RN SERIES TECHNICAL BULLETIN

ISSUE NO. : RNT-015

SUBJECT: 021-16027-006 Bracket B; Junction Gear

Newly-registered Part
021-16027-006 Bracket B; Junction Gear

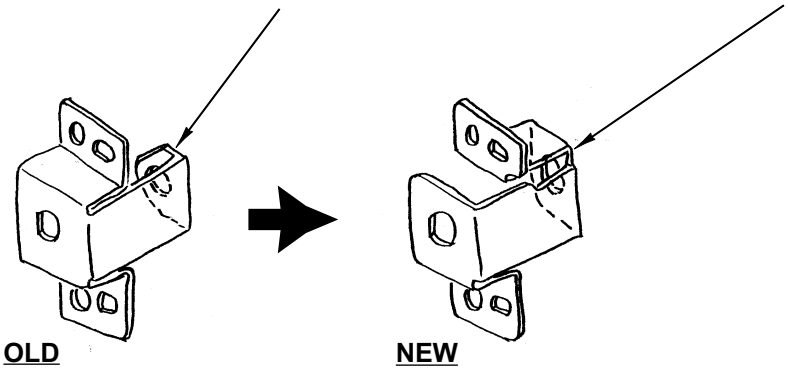
Brief:
The shape of the bracket is changed to give more strength.

Reason:
In some cases, the old type Bracket deformed during printing operation and resulted in breakage of the Junction Gear on the Drum.

This portion of the Bracket was weak in design . The new design gives more strength.

OLD
021-16025-208
Bracket; Junction Gear

NEW
021-16027-006
Bracket B; Junction Gear
